City of Miami Beach
Last Completed Item Reviews Across All Submittals

Permit Type: Building - Commercial **Work Class:** Alteration (w/o Phased) **Application Date:** 05/22/2020 **Status:** Approved
Address: 235 WASHINGTON AVE **Permit:** BC2013662

Re: Response to City Comments.

Sobe Hostel
235 Washington Ave.
Miami Beach, Florida

1 LEVEL ONE - FIRE PROTECTION FLOOR PLAN
SCALE: 3/16" = 1'-0" N

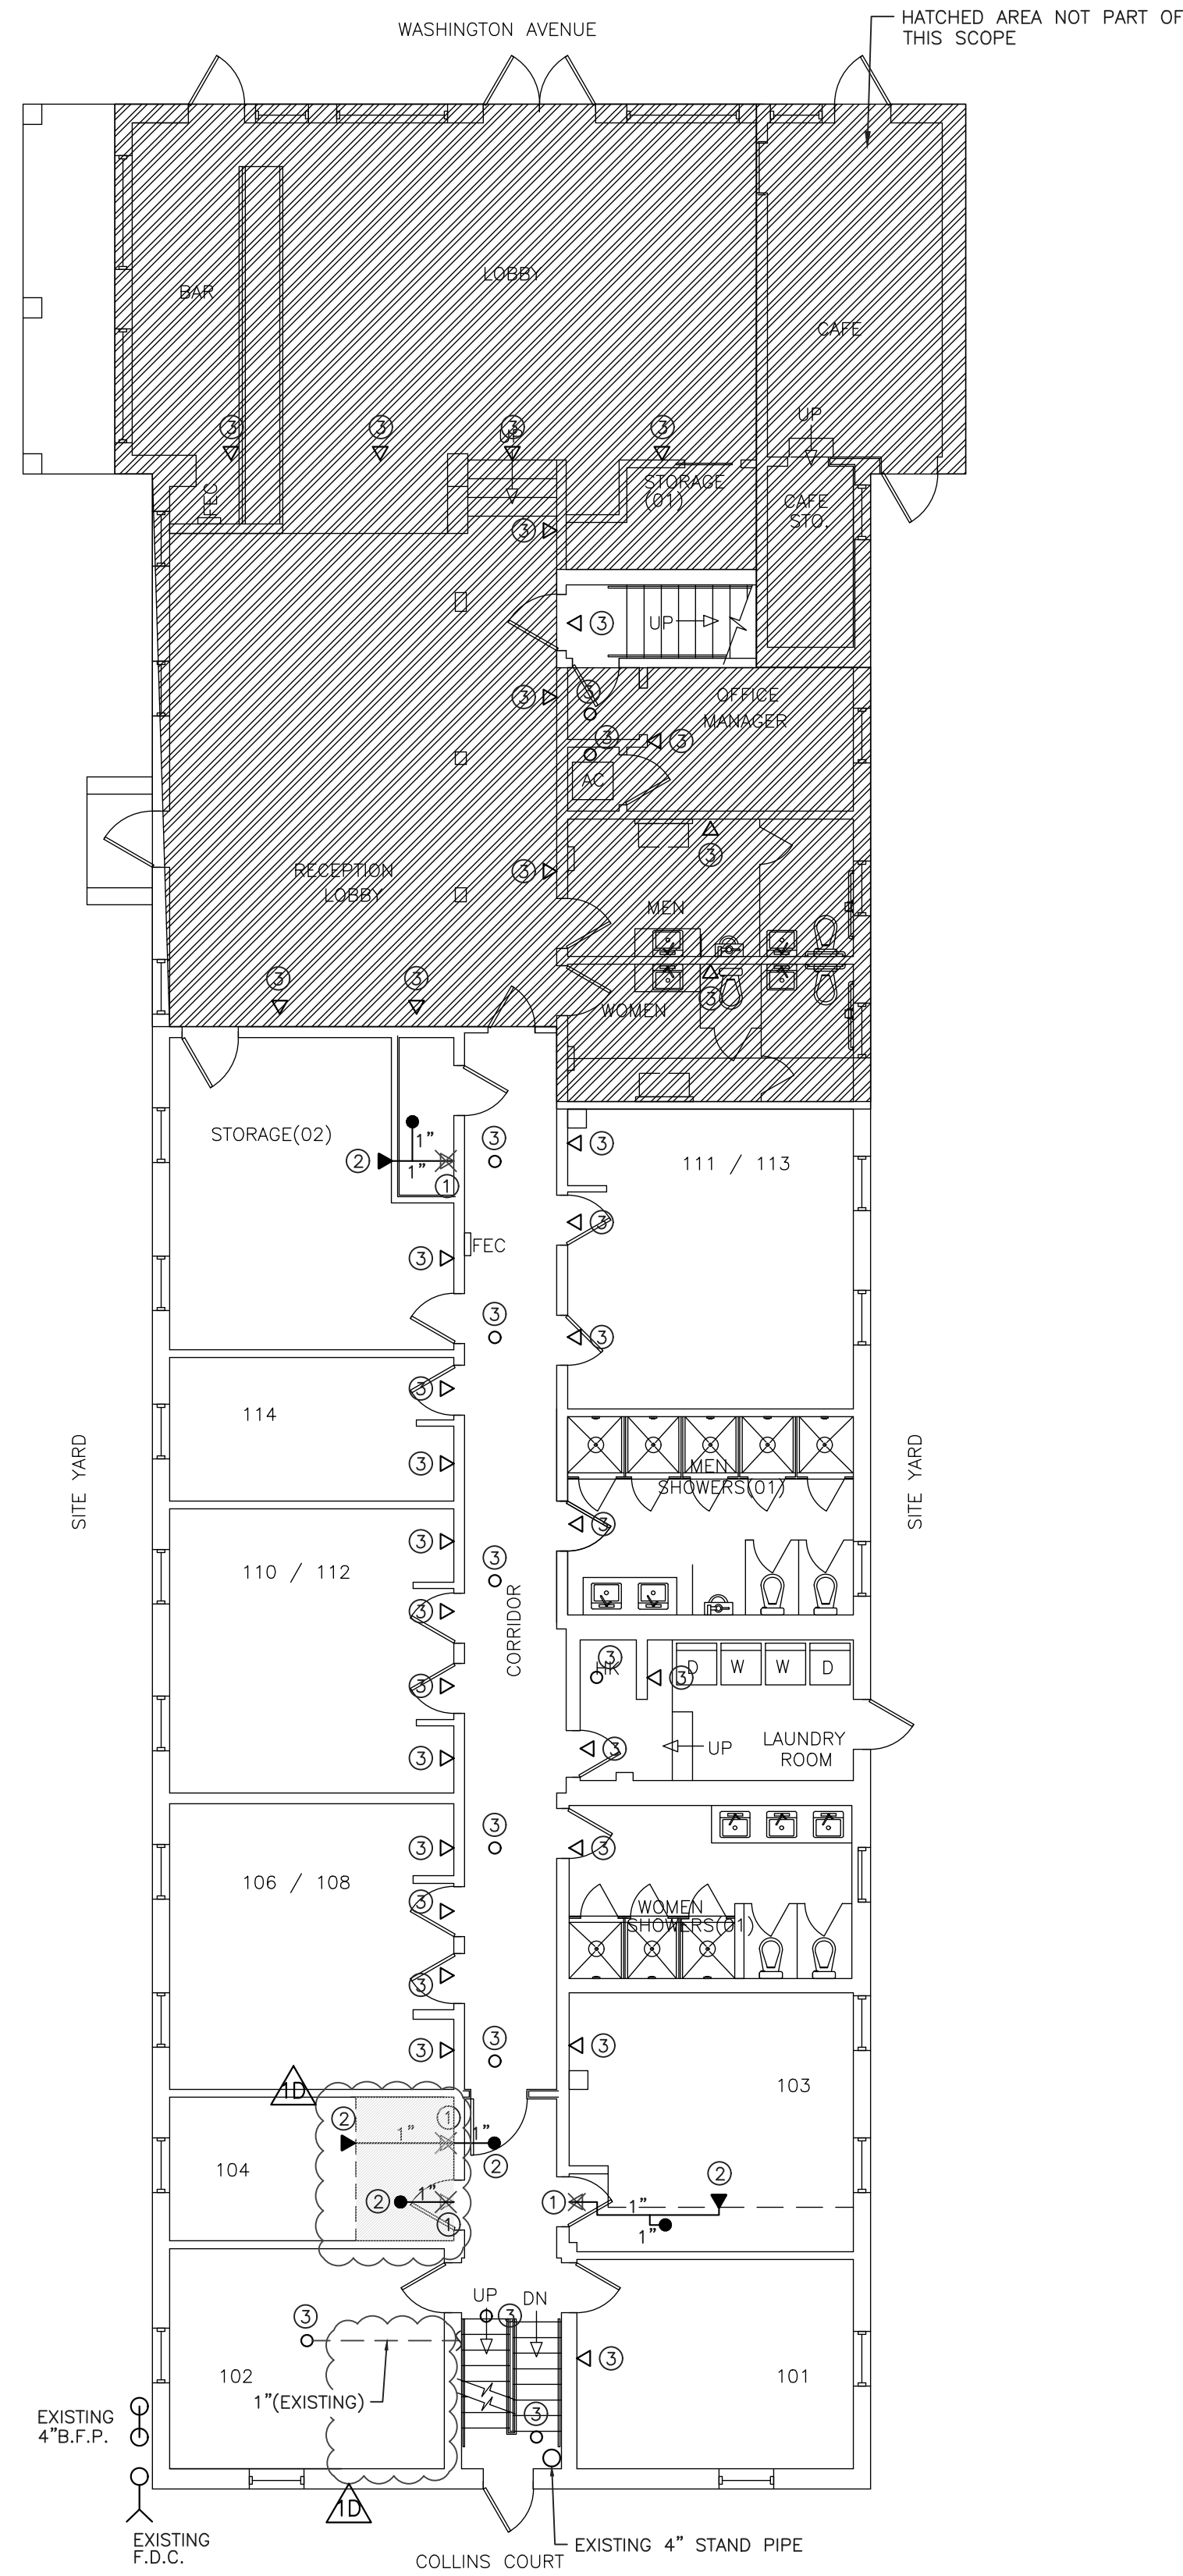
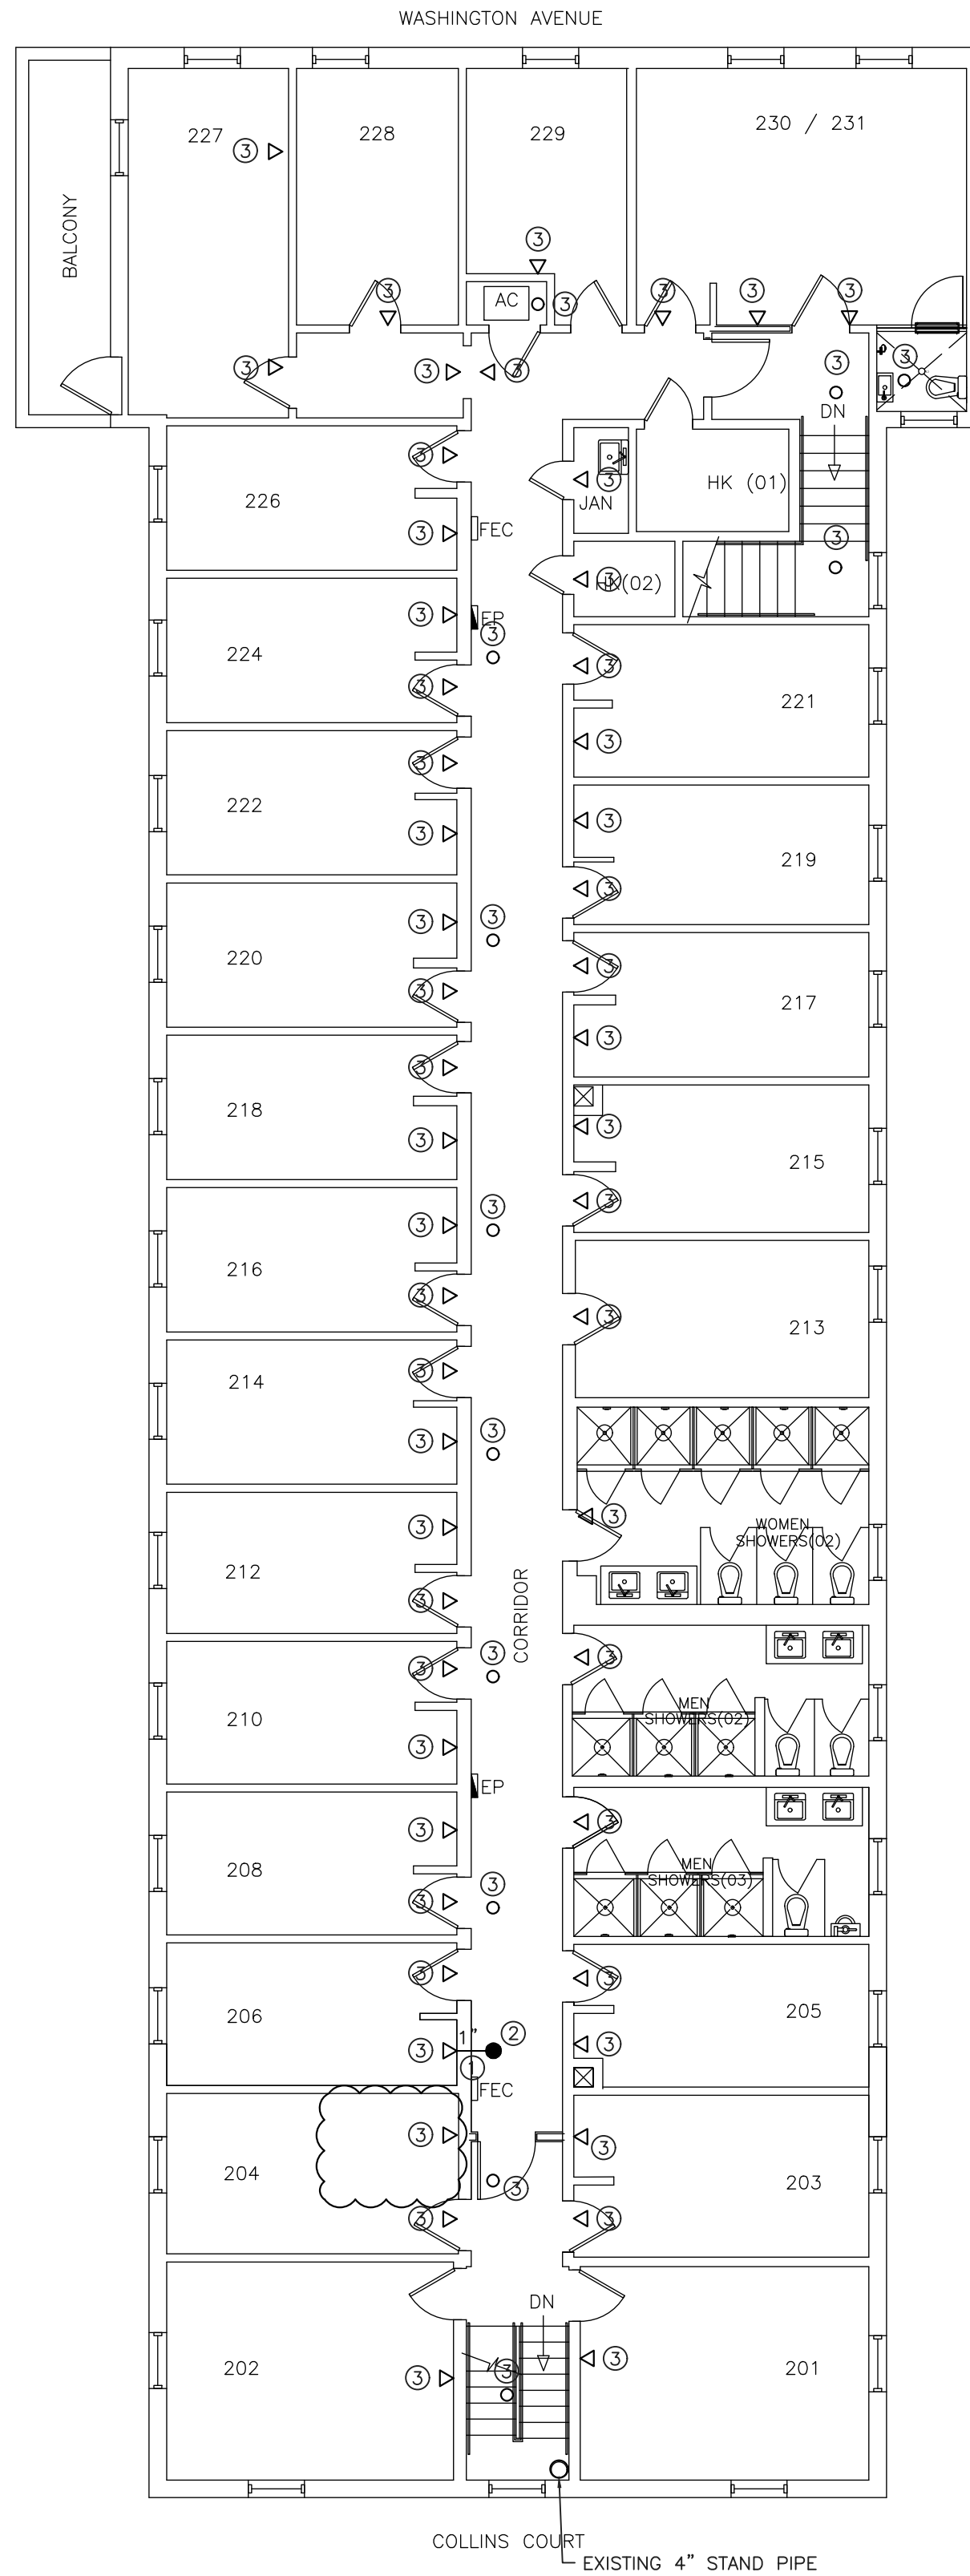
1. Plans stated building is sprinklered, but did not provide the set to verify scope of work did not affect original approved design for the building

KKAID Response: Refer to sheets FP101 and FP201

LIFE SAFETY PLAN LEVEL 1 & 2

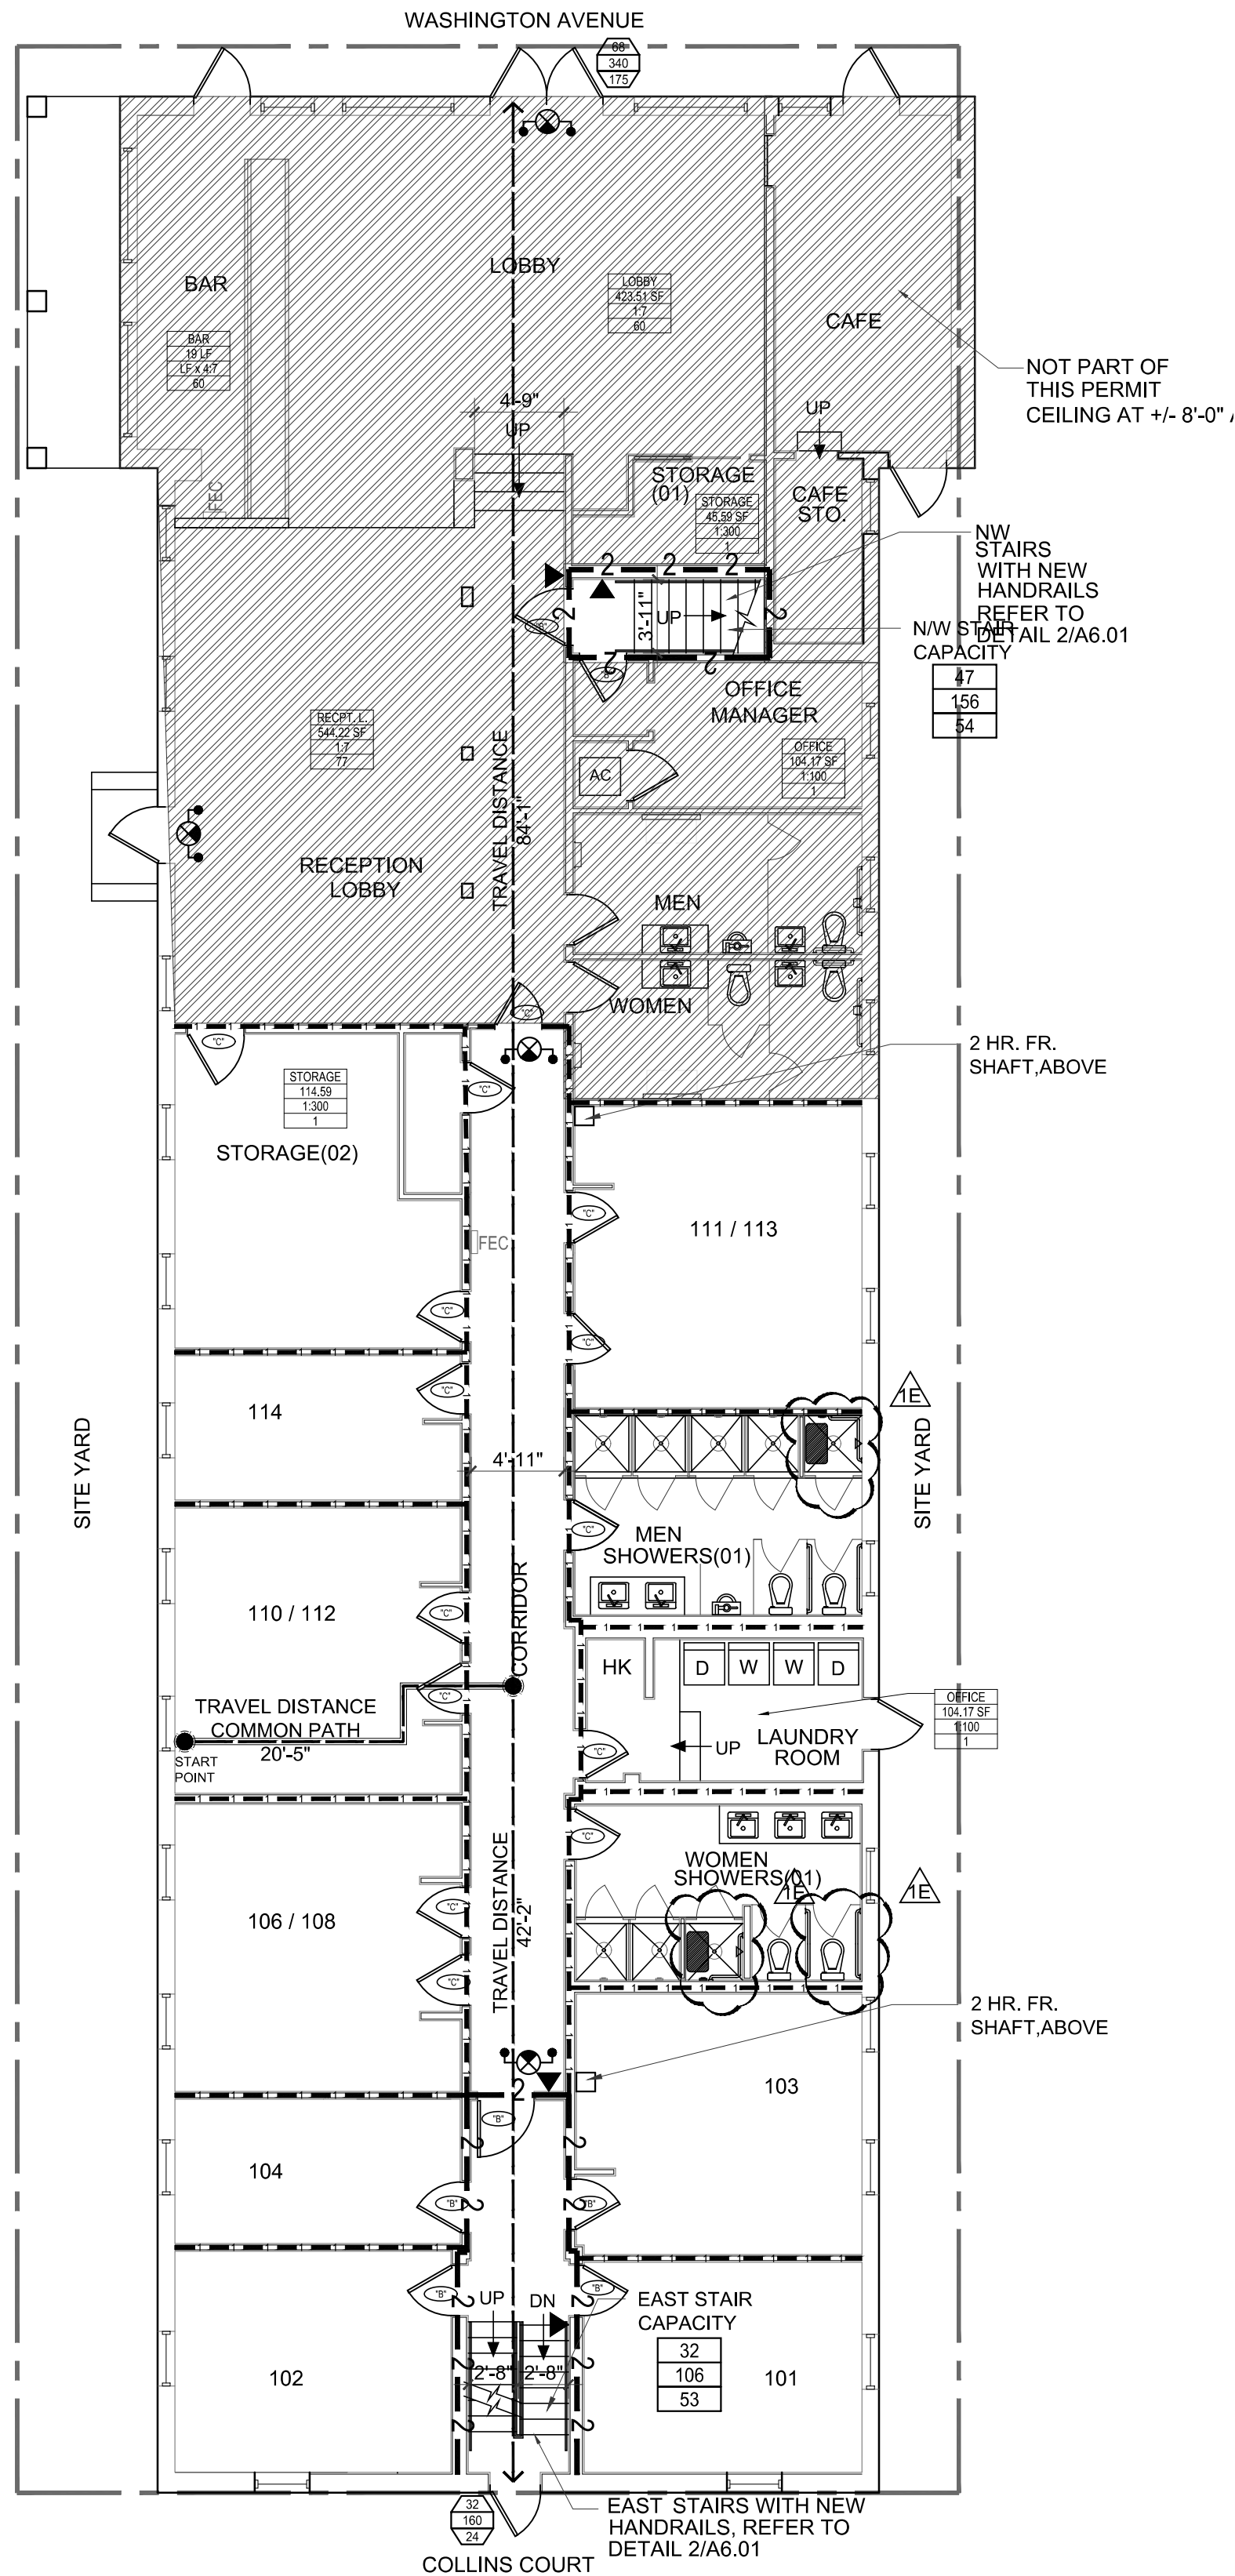
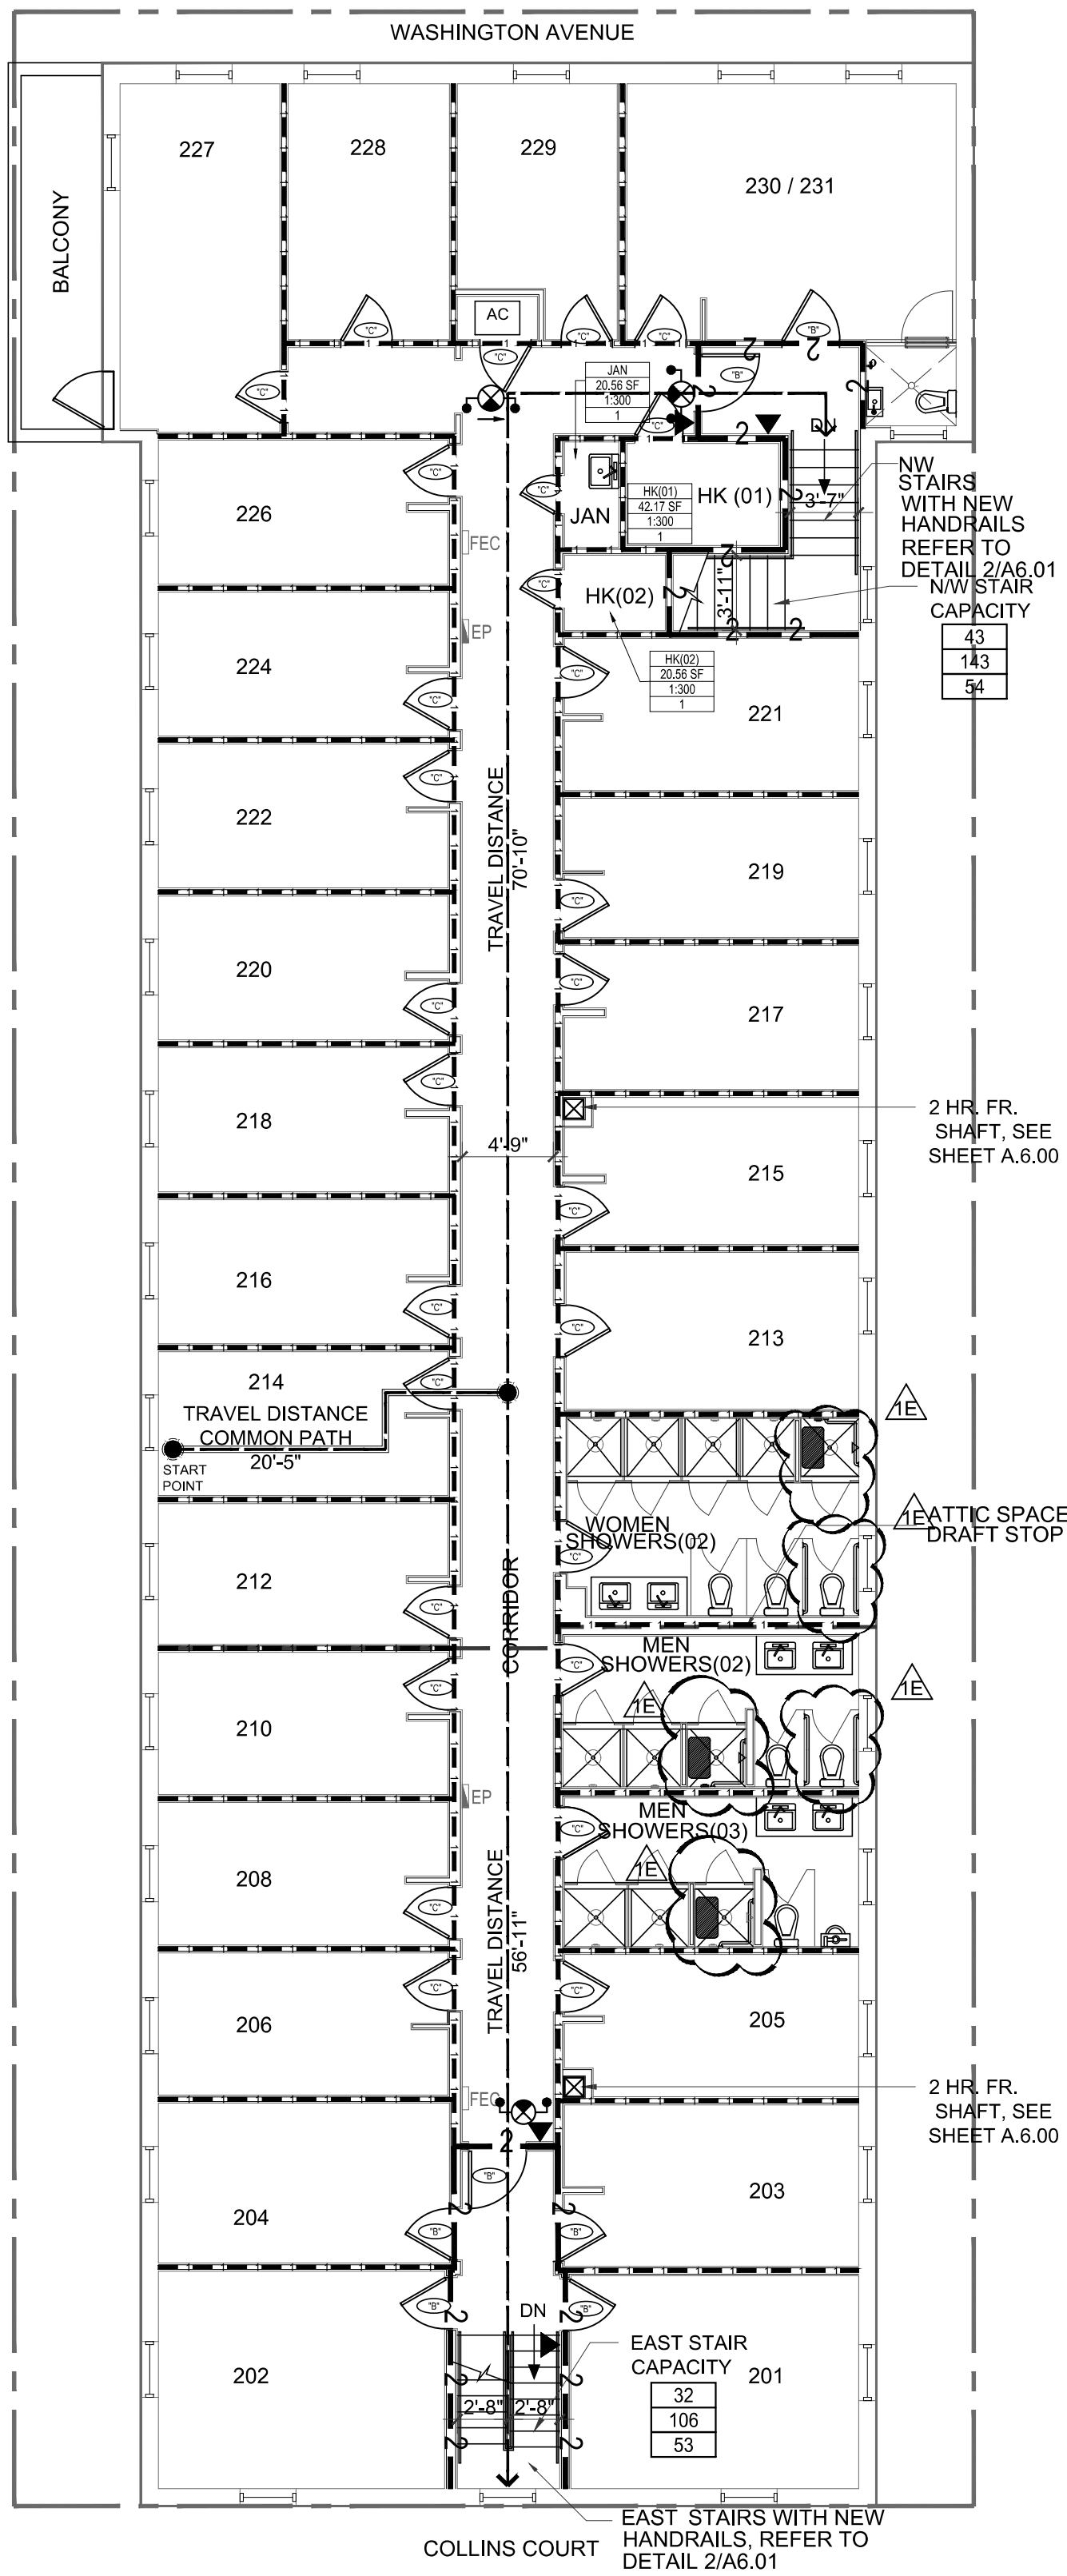
1. Provide the rating of the exit stairs to verify compliance with the fppc 6th ed

KKAID Response: Refer to Life-Safety sheet A2.00 for identification of the fire rated partitions (existing and proposed). This sheet is only the Proposed Floor Plan showing dimensions and wall tags of new partitions
